PIC18F2455/2550/4455/4550

PIC18F2455/2550/4455/4550 Rev. A3 Silicon Errata

The PIC18F2455/2550/4455/4550 parts you have received conform functionally to the Device Data Sheet (DS39632D), except for the anomalies described below. Any Data Sheet Clarification issues related to the PIC18F2455/2550/4455/4550 will be reported in a separate Data Sheet errata. Please check the Microchip web site for any existing issues.

FIGURE 1: SCK PULSE VARIATION USING TIMER2/2

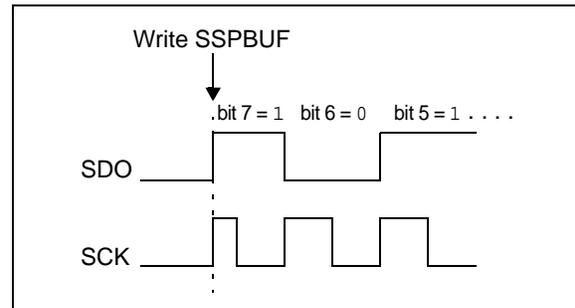
When the SPI is using Timer2/2 as the clock source, a shorter than expected SCK pulse may occur on the first bit of the transmitted/received data (Figure 1).

To avoid producing the short pulse, turn off Timer2 and clear the TMR2 register, load the SSPBUF with the data to transmit and then turn Timer2 back on. Refer to Example 6 for sample code.
